Re: Petition 1352 - Nutmeg Solar, LLC, petition for a declaratory ruling, pursuant to Connecticut General Statutes §4-176 and §16-50k, for the proposed construction, maintenance and operation of a 19.6-megawatt AC solar photovoltaic electric generating facility on approximately 162 acres comprised of 9 separate parcels located generally south of Bailey Road and east of Route 191 (Broad Brook Road), and associated electrical interconnection to Eversource Energy's Scitico Substation at 20 Bailey Road in Enfield, Connecticut

Petition No. 1352

CSC-1 Condition No. 1(a) of the Council's Declaratory Ruling (Declaratory Ruling) dated April 26, 2019 requires, "The D&M Plan shall be served on the Towns of Enfield and Somers for comment..." Was a copy of the Development and Management Plan (D&M Plan) submitted to the Towns of Enfield and Somers? If no, please submit a copy to these two municipalities.

CONNECTICUT
NUTMEG SOLAR
115/34.5kV SUBSTATION
ABOVE GRADE SECTION H-H

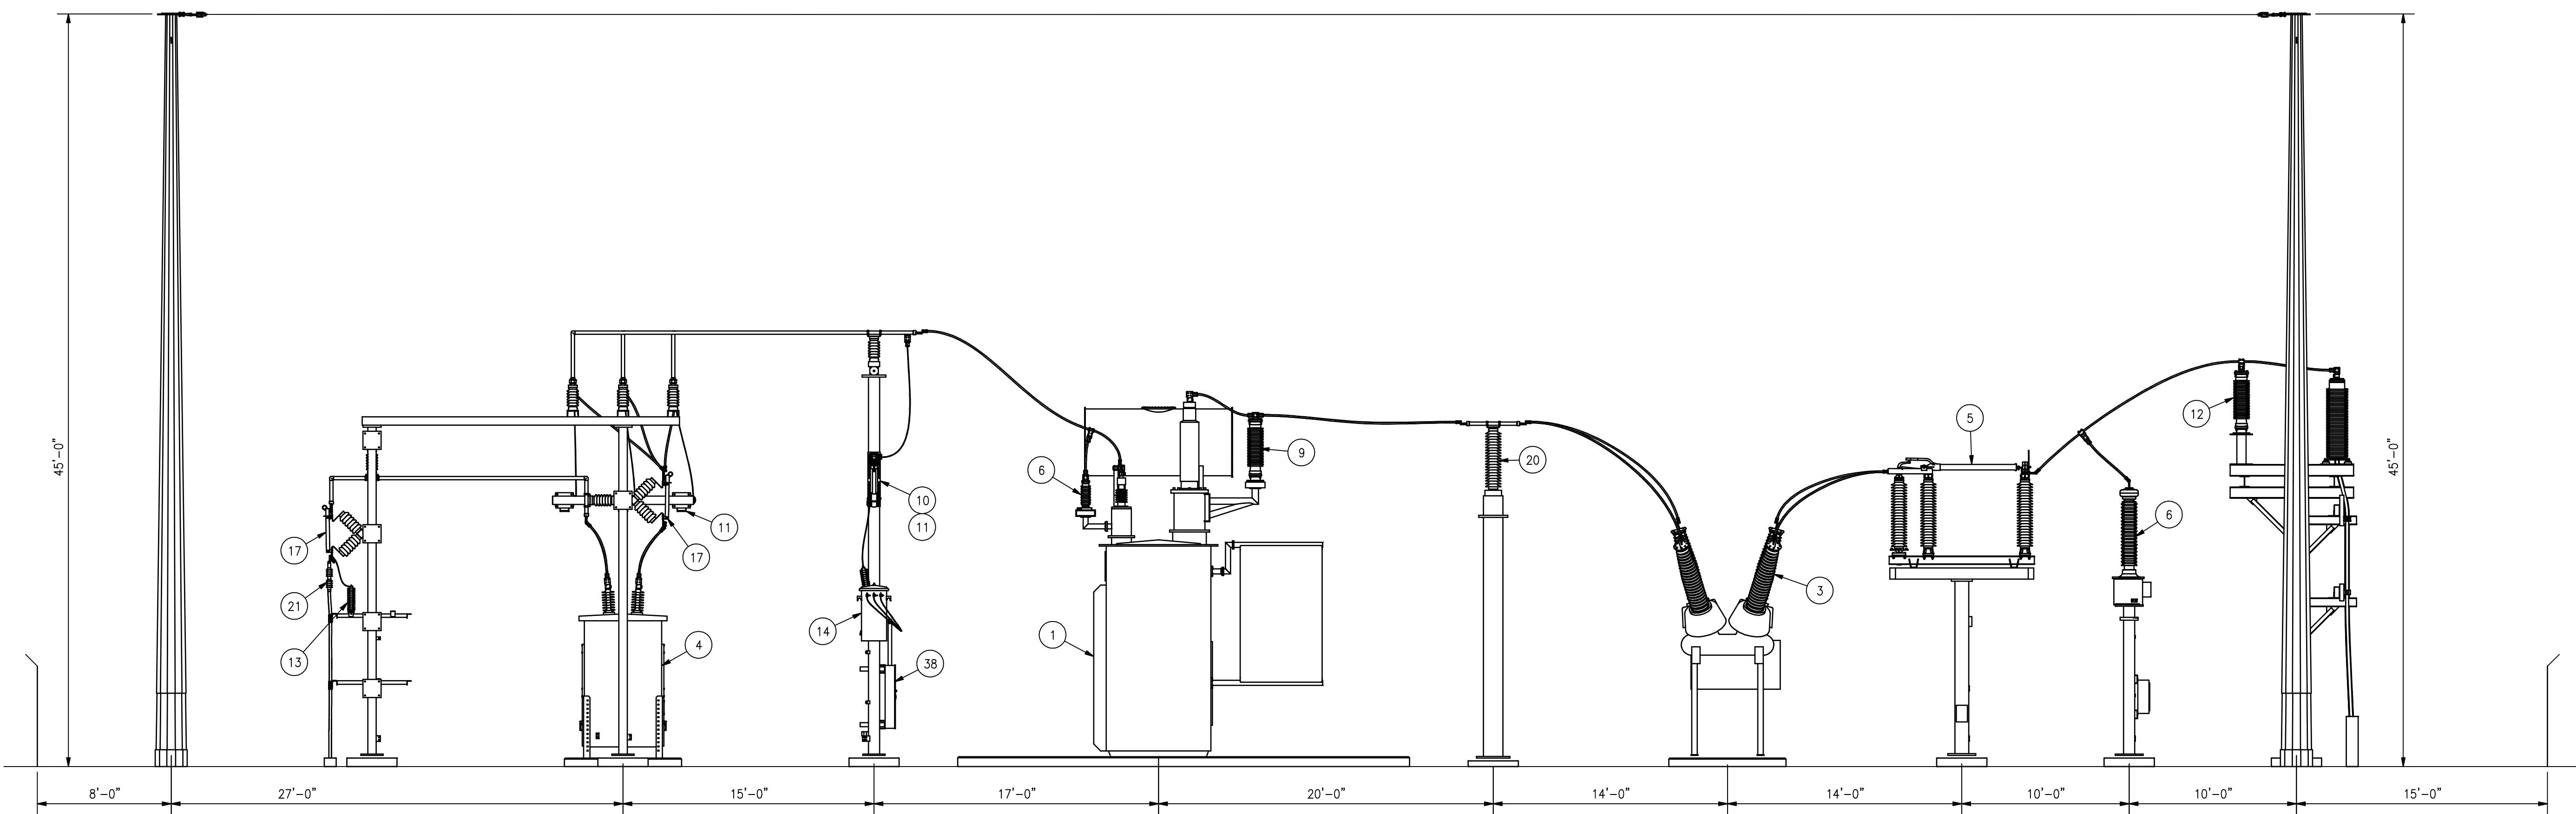
CSC-2 Condition No. 1(a) of the Declaratory Ruling also requires, “A final site plan including, but not limited to, solar arrays, fence design, and the electrical connections to and including the Collector Substation.” Drawing Nos. C-024 and C-025 of the Development and Management Plan (D&M Plan) only depict the rectangular area for the Collector Substation with a note that states, “Refer to Electrical Drawings for Substation.” Please provide the site plan/electrical drawings of the Collector Substation. Include the substation structure/equipment heights and the connection to Eversource’s approved underground transmission line from Petition No. 1376.

A 115/34.5 kV Substation General Arrangement Plan and 115/34.5kV Substation Above Grade Section H-H are being submitted with this response.

See Attachment CSC-2 – 115/34.5 kV Substation General Arrangement Plan and 115/34.5kV Substation Above Grade Section H-H drawing sheets.
